UPGRADE: NEW VERSION PA970S

In conformity with the above OEM choice, Saleri has developed the same reinforced version; identified by the reference **PA970S** – equipped with the same bearing found on the original water pump.

Roller-ball bearing with 3 contact points

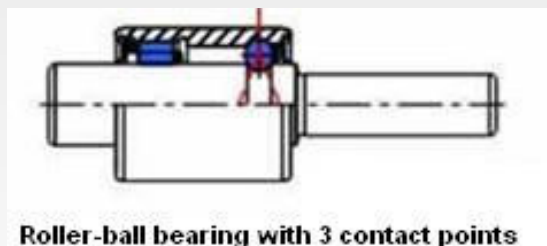
The original water pump for Renault and Nissan (Renault 7700105378; Nissan 2101000QAA - 1.4 and 1.6 petrol engines) has been recently updated through the introduction of the innovative INA roller-ball bearing with angular contacts.

The "S" sign indicating the new reference has been indelibly stamped on the pump, in order to allow the distinction from the normal version PA970.

In accordance with OES specification PA970S is strictly required for the following application:

Renault Clio 1.6 16v (engine: K4M800/801/804) from 4/05-

PA970S is also suggested for all the other applications, although the normal version of the pump PA970 is still available as a cheaper alternative.
